Kennecott Uranium Company
Sweetwater Uranium Project
42 Miles NW of Rawlins
PO Box 1500
Rawlins, Wyoming 82301-1500
USA
T +1 (307) 328-1476
F +1 (307) 324-4925

**Subject: Sweetwater Uranium Project – Docket Number: 40-8584
Source Material License SUA-1350 - Response to the August 25, 2016 Letter Entitled
Draft Renewal Materials License, Sweetwater Uranium Project, Sweetwater County,
Wyoming**

FIGURE 5-3
NRC MILL AREA MONITORING LOCATIONS, RESUMED OPERATIONS, FIRST NEW TAILINGS IMPOUNDMENT AND EVAPORATION PONDS

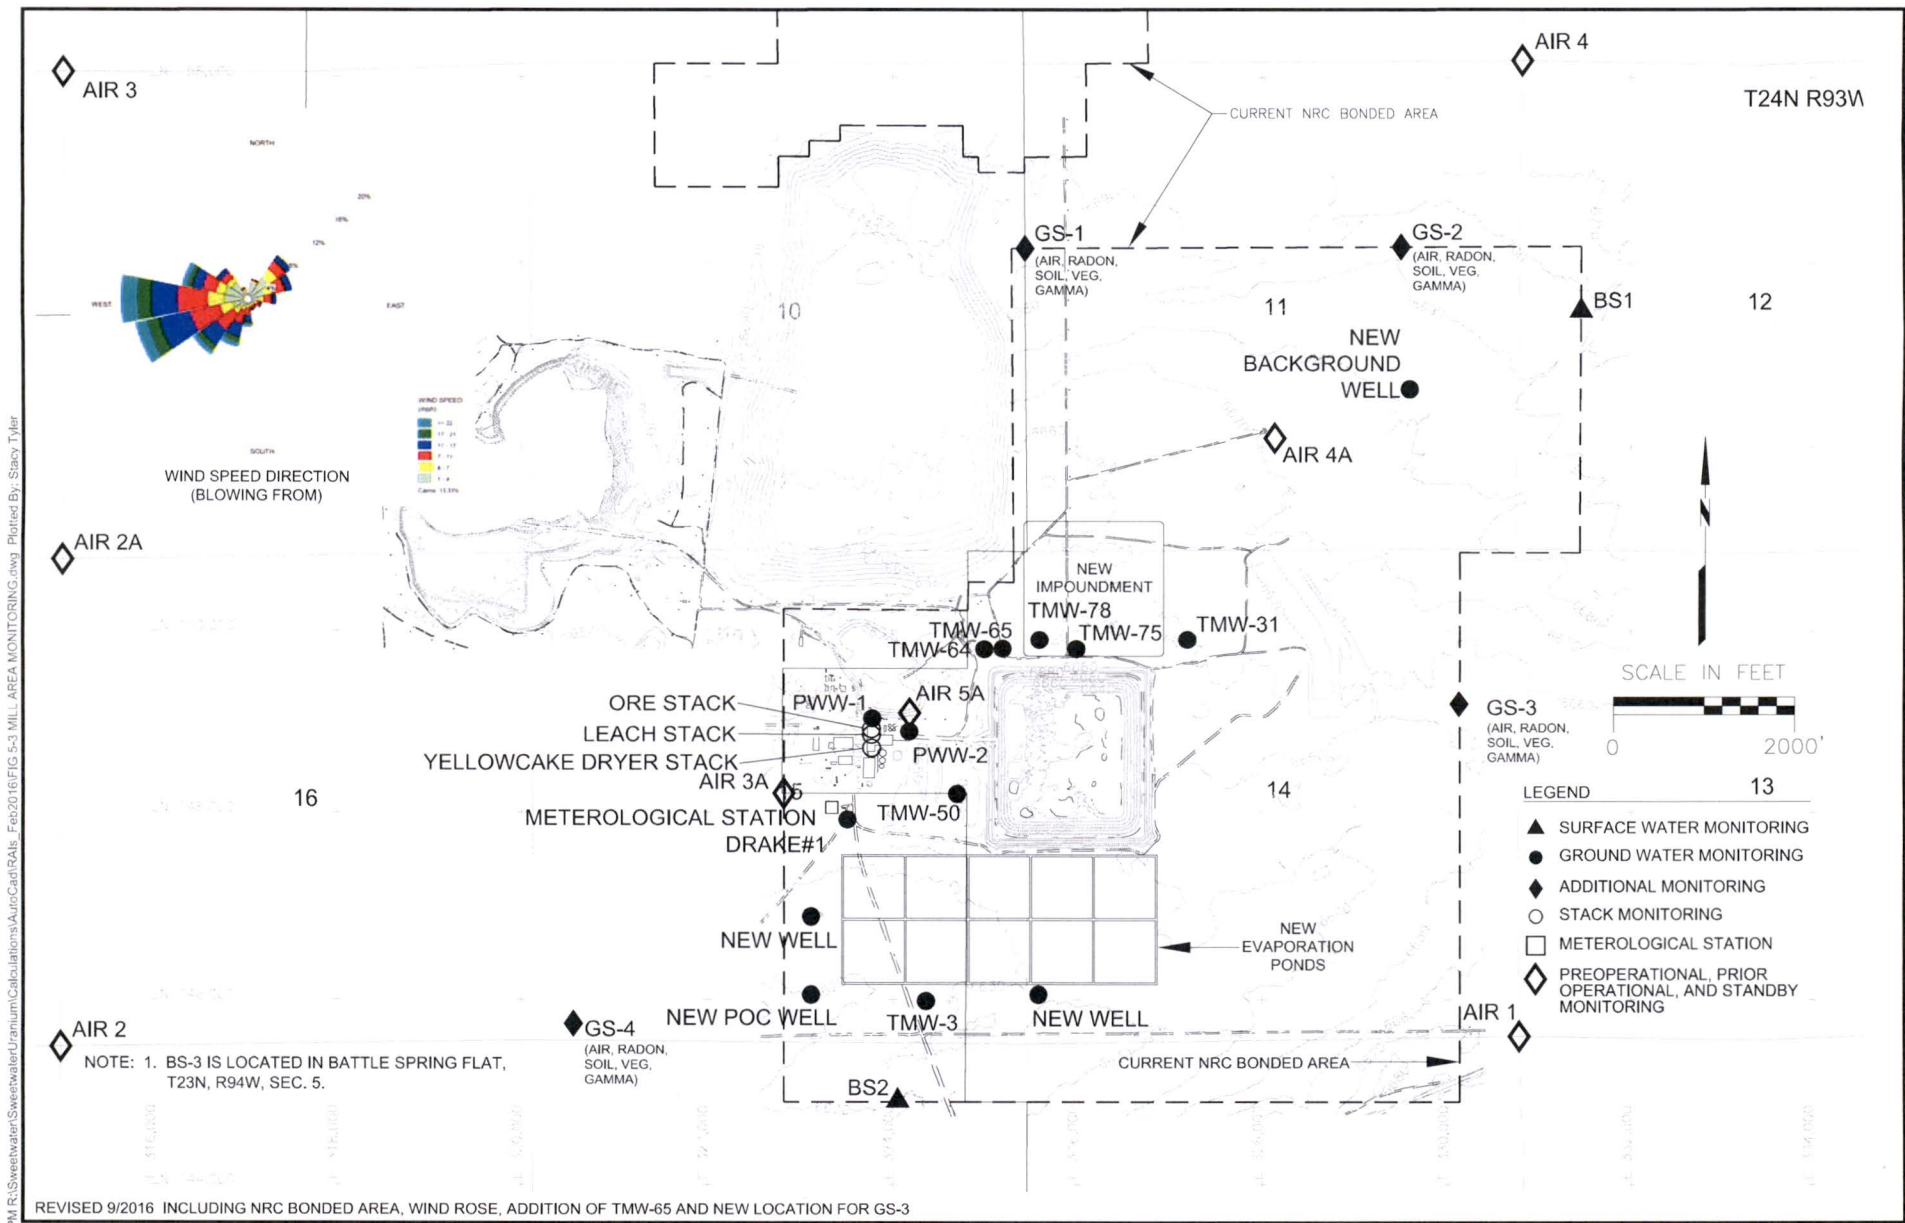
- Kennecott Uranium Company has revised *Figure 5-3 -NRC Mill Area Monitoring Locations, Resumed Operations, First New Tailings Impoundment And Evaporation Ponds* by relocating air monitoring station GS-3 to a point east of the facility so that it is in line with the predominate wind direction, and including a current wind rose on the drawing. This revised figure is included with this letter.
- Kennecott Uranium Company is developing a detailed discussion of the air effluent monitoring program that will be submitted by September 30, 2016.
